# Notice of Modification

## Section 4.55(2) of the *Environmental Planning and Assessment Act 1979*

The development consent for the Crudine Ridge Wind Farm (SSD-6697), granted by the Planning Assessment Commission, as delegate of the Minister for Planning, on 10 May 2016.

#### **Aarons Pass Road Upgrades**

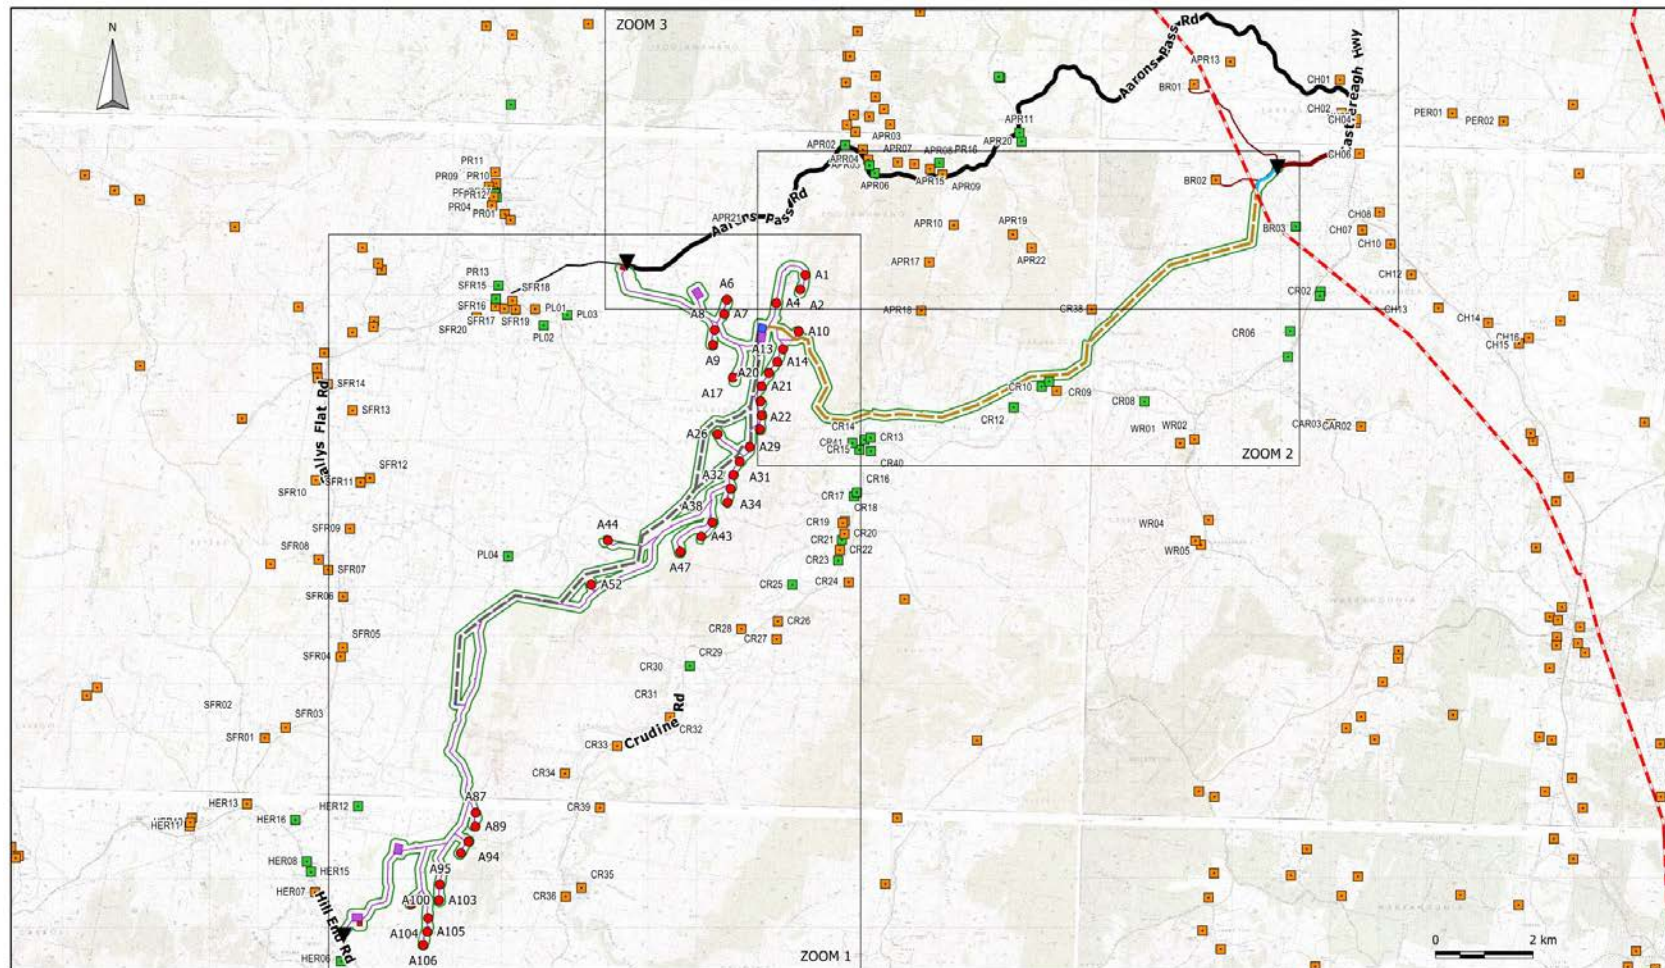
25. In Appendix 1:
- above the first table, insert the sub-heading 'Wind Farm'; and
  - after the first table, insert the following:

## APPENDIX 2 GENERAL LAYOUT OF THE DEVELOPMENT

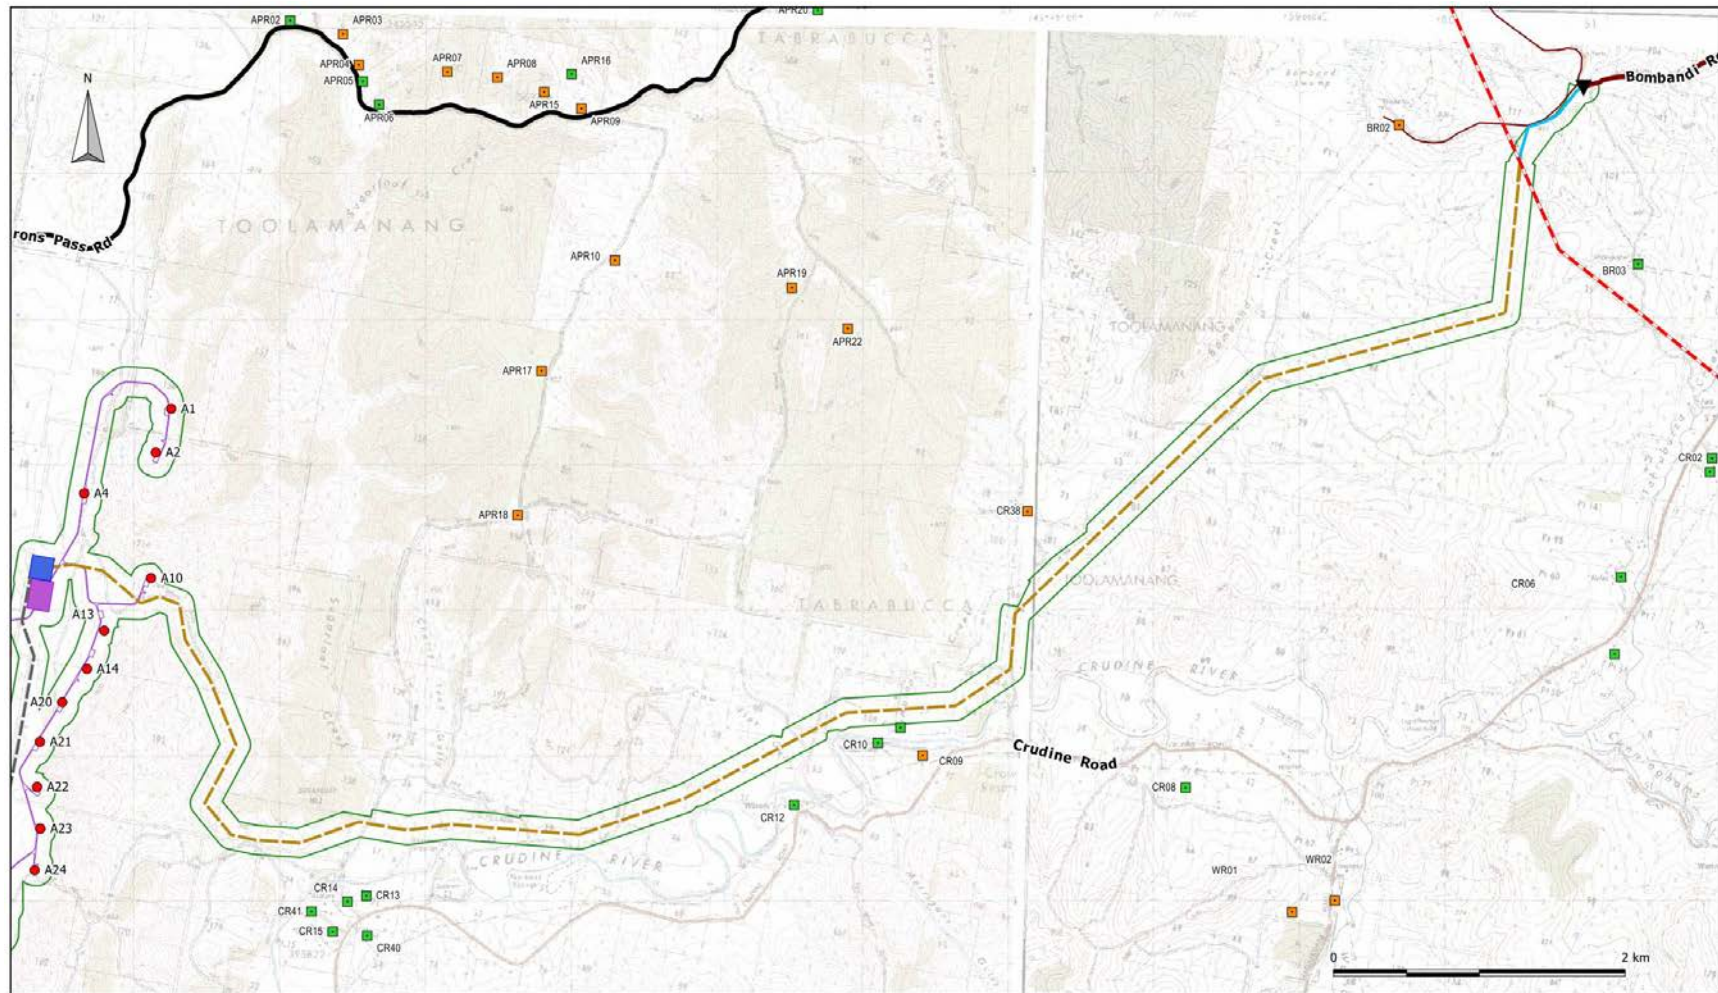
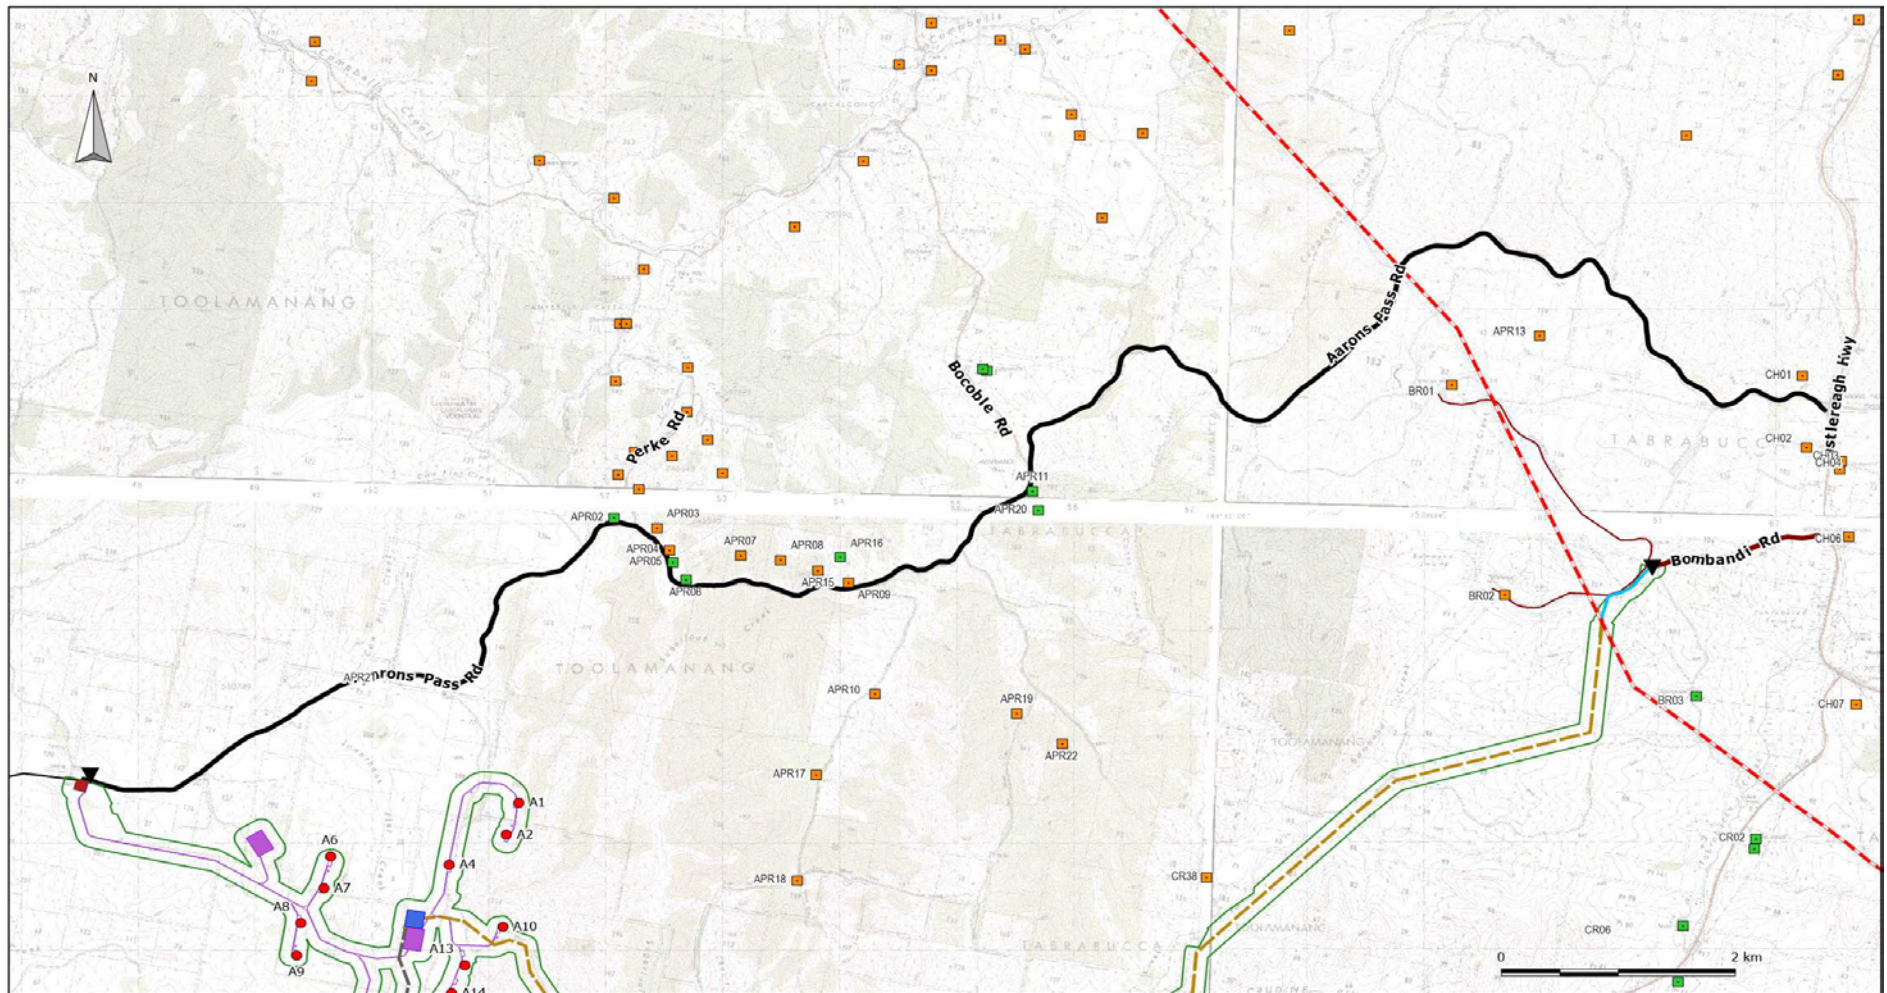
26. Delete Appendix 2 and replace with the following:

## APPENDIX 5 BIODIVERSITY OFFSET AREA

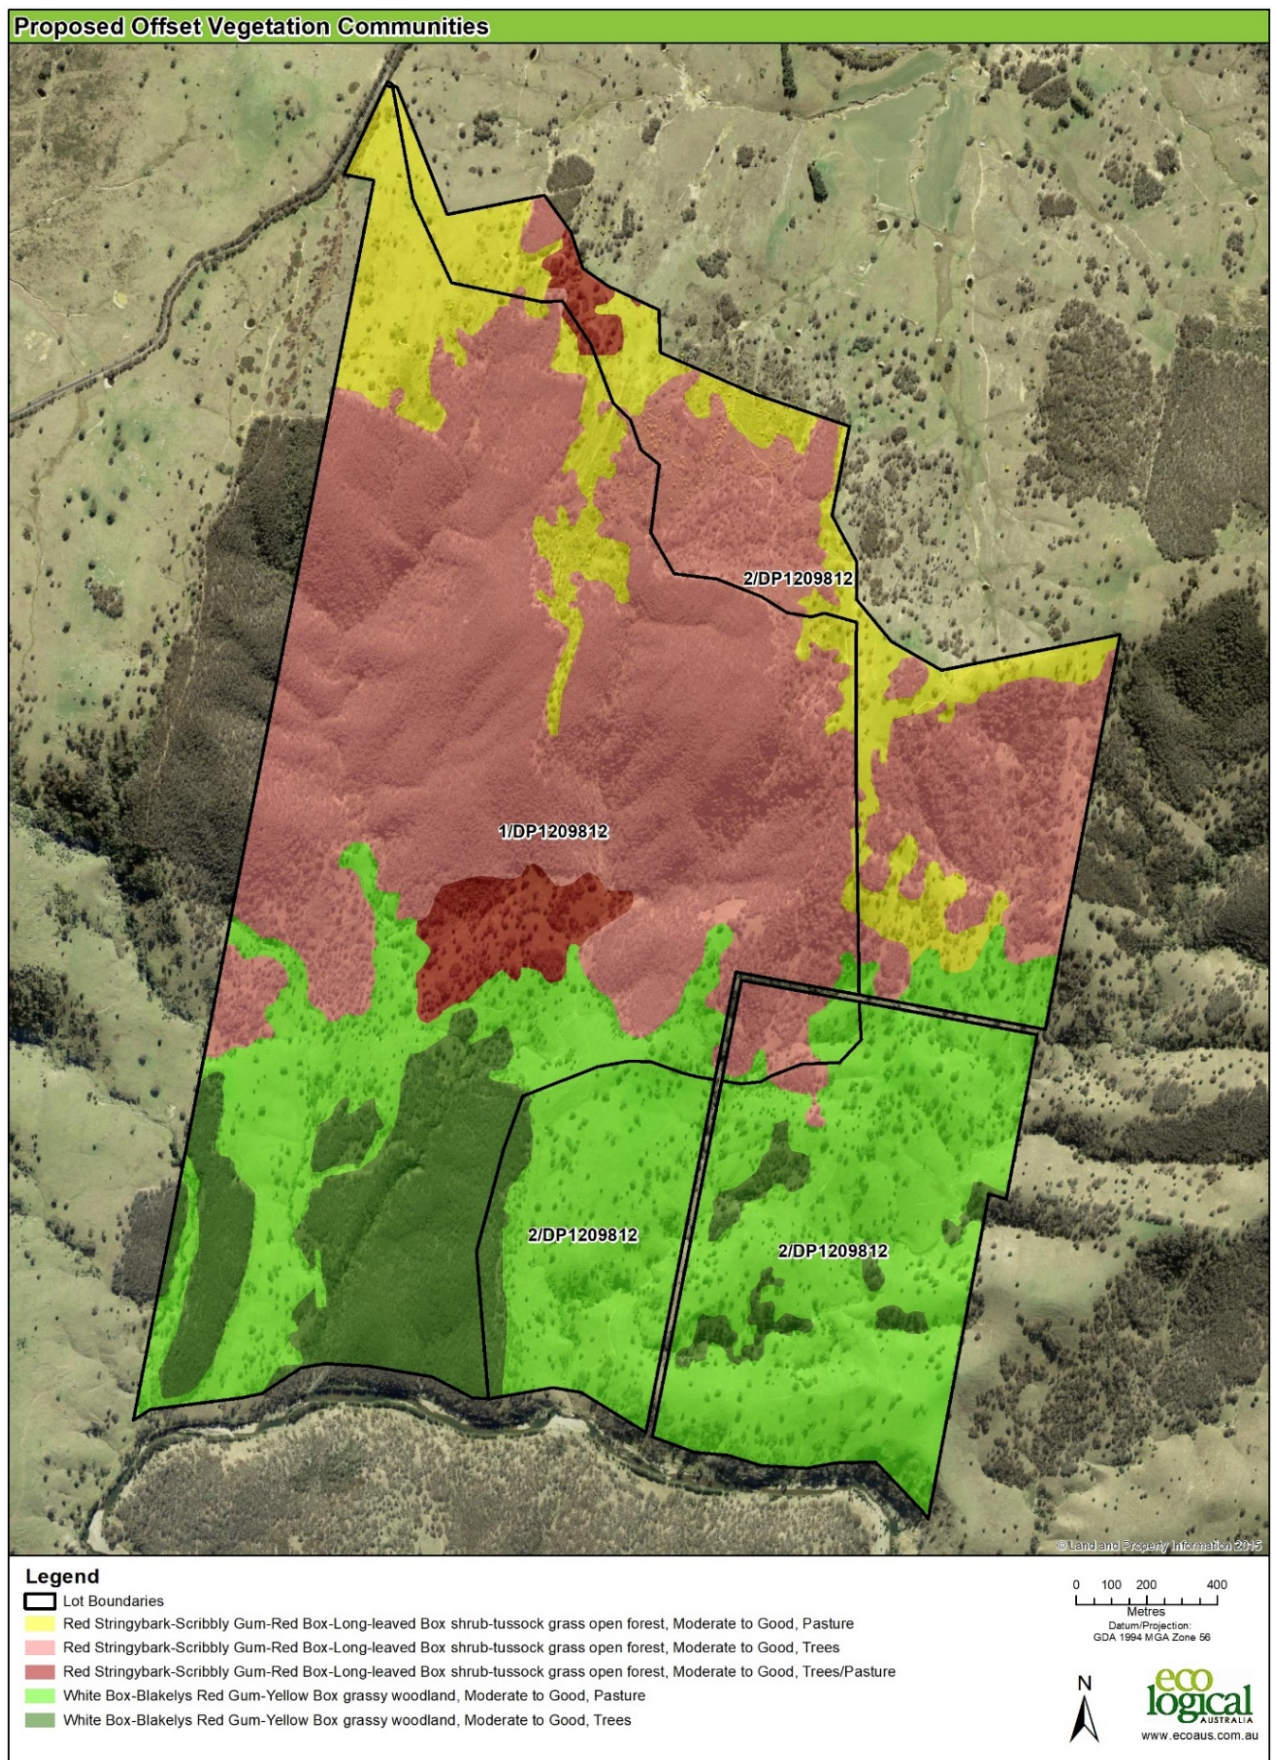
27. Delete Appendix 5 and replace with the following:
